October 14, 1985
ST-HL-AE-1407
File No.: G9.17

South Texas Project
Units 1 and 2
Docket Nos. STN 50-498, STN 50-499
Responses to DSER/FSAR Items;
LOCA Break Discharge Coefficient

FIGURE 1. PEAK CLAD TEMPERATURES FROM 1978 MODEL ANALYSIS FOR TGX.

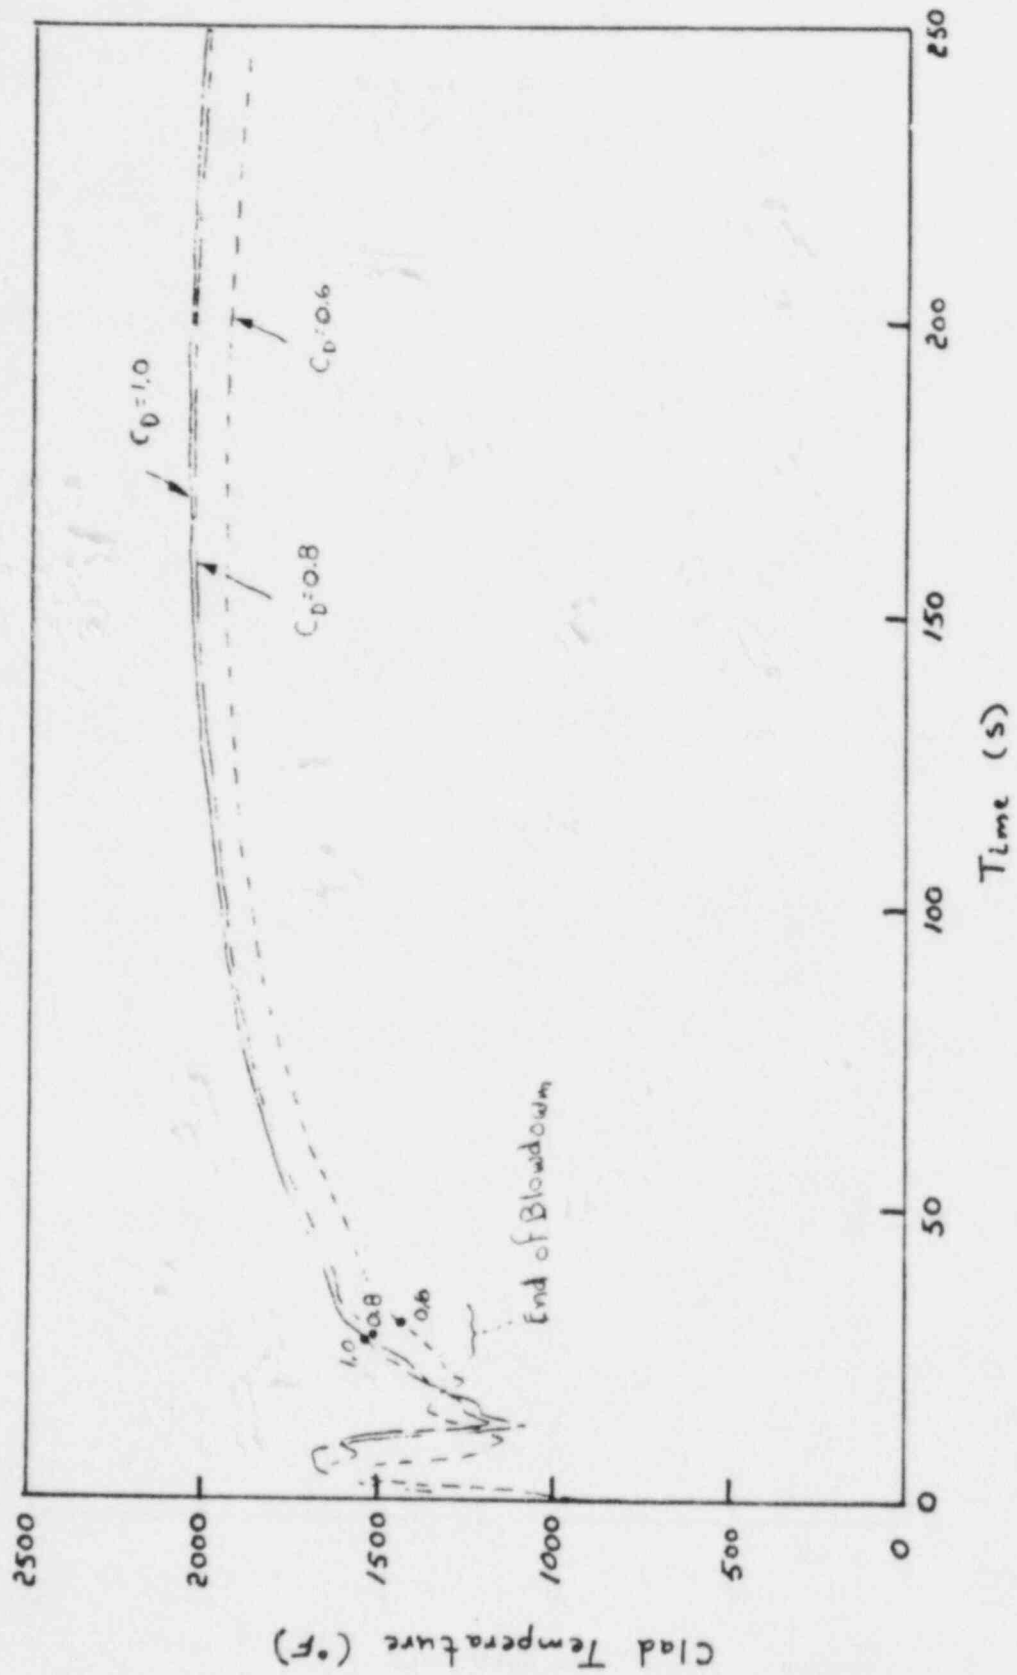
The question was in reference to the fact that the break discharge coefficient corresponding to the highest peak clad temperature (PCT) is different for the current analysis performed with the BART code (STP Amendment 51), which predicted a worst discharge coefficient (CD) of 0.6, than it was for the previous analysis performed with the Westinghouse 1978 Evaluation Model (STP Amendment 18), which predicted a worst CD of 1.0.

Attached are two figures which show the peak clad temperature (PCT) responses from the three CD's calculated for each analysis. As seen from the curves, the reflood phase of all of the transients in each analysis are very similar. The gravity-driven forces for reflooding the core are essentially the same for any case, and the variation in CD's has little effect on containment pressure and the relatively low flowrates associated with reflood. With similar reflooding behavior and the fact that adiabatic heating is assumed for the refill phase of the transient, the PCT attained will be determined based upon rod cladding temperature at the end of blowdown, which in turn is governed by the blowdown codes used.

In conclusion, the fact that for South Texas the worst case CD has changed from one analysis to the next is a function of different codes being employed in the two analyses in question. The presently used Westinghouse 1981 Model SATAN-VI code is recognized as being an improvement over the 1978 Model, and the prediction of worse CD's near the smaller end of the spectrum is a credible consequence in view of the phenomena governing PCT.
